WENATCHEE HISTORIC PRESERVATION BOARD REGULAR MEETING APRIL 6, 2022

STAFF REPORT HP-22-01, 511 DOUGLAS STREET

FROM: City of Wenatchee Community Development Staff **RE:** Certificate of Appropriateness for 511 Douglas Street

Description of Request: This is an application for a Certificate of Appropriateness submitted by the property owner for removal of the planter strip in the public right-of-way adjacent to the property located at 511 Douglas Street. The work was completed without the issuance of a right-of-way permit or Certificate of Appropriateness and includes the removal of the planter strip and replacement of the planting area with poured concrete. This residence is listed as a contributing, historic structure in the Grandview Historic District. Application materials are included as Attachment A.

Code Compliance email, March 16, 2022

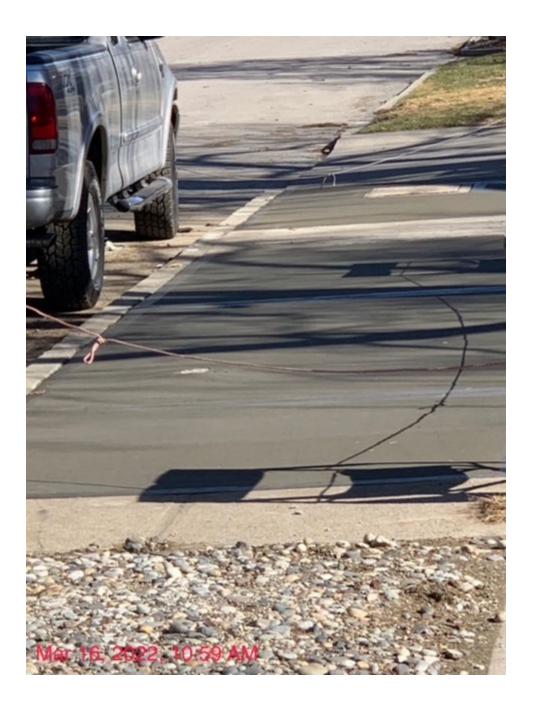
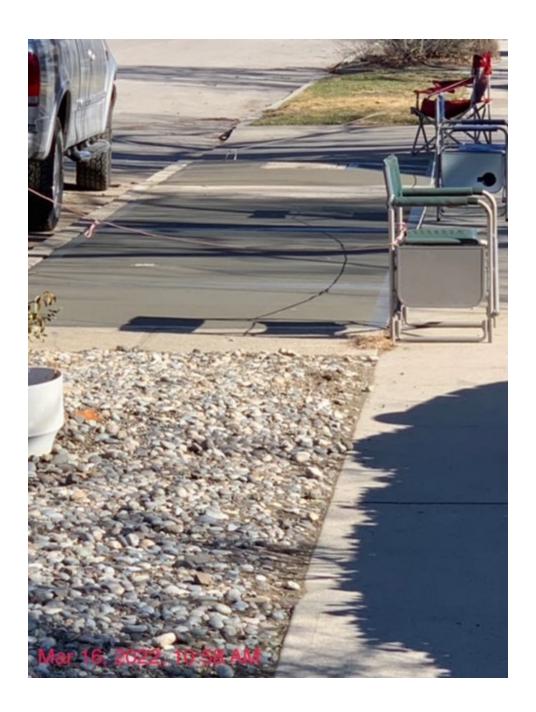
511 Douglas, which is in the Grandview Historic District has put concrete in the planter strip. Is that allowed there?

There is no evidence of a safety problem. No request was made for involvement by the city Engineer prior to paving, nor any application for permit to work in the right-of-way to pave the planter strip at 511 Douglas.
